SDARS/WCS Rulemaking

Sirius Satellite Radio Inc. & XM Radio Inc.

Technical Presentation to FCC International Bureau

April 24, 2008

Figure 1. WCS Coalition proposed OOB mask for mobile CPE

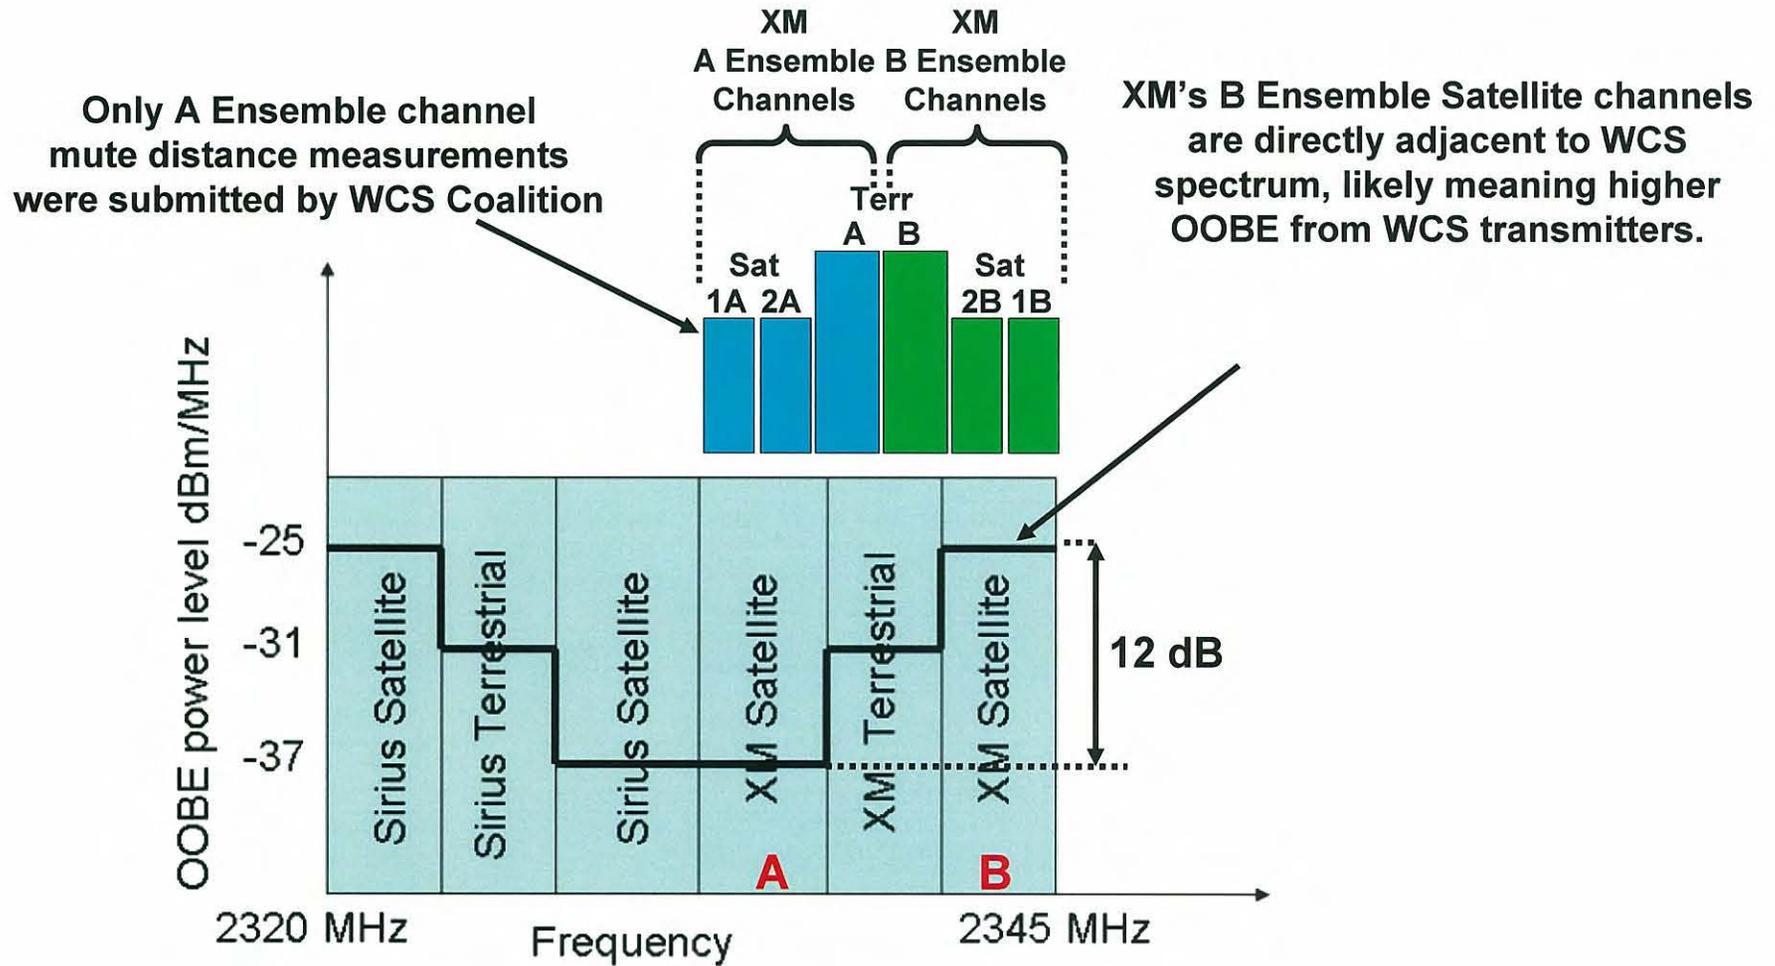
2. OOB Test Methodology Overly Narrow and Fundamentally Flawed

- Never measured interference to XM satellite channels located closest to WCS band (testing limited to “free” channel in Ensemble A)
 - Underestimated interference levels by 12 dB
 - Stepped OOB mask inappropriate, because it sanctions added interference to half of SDARS downlink channels.

In contrast, accurate tests should have a flat OOB mask.
- Best-case interference measurements result in overly-optimistic conclusions
 - Clear line-of-sight to SDARS satellites (no link margin sacrificed for foliage, terrain or other blockage)
 - Stationary receiver (no link margin sacrificed for fading)
 - Best case geographical test locations for strongest satellite signal (strongest possible sat signals for high $S/(I+N)$)
- In contrast, normal, real-world conditions with reduced link budget due to foliage, mobility, location, etc., will expand the WCS-generated muting zones.
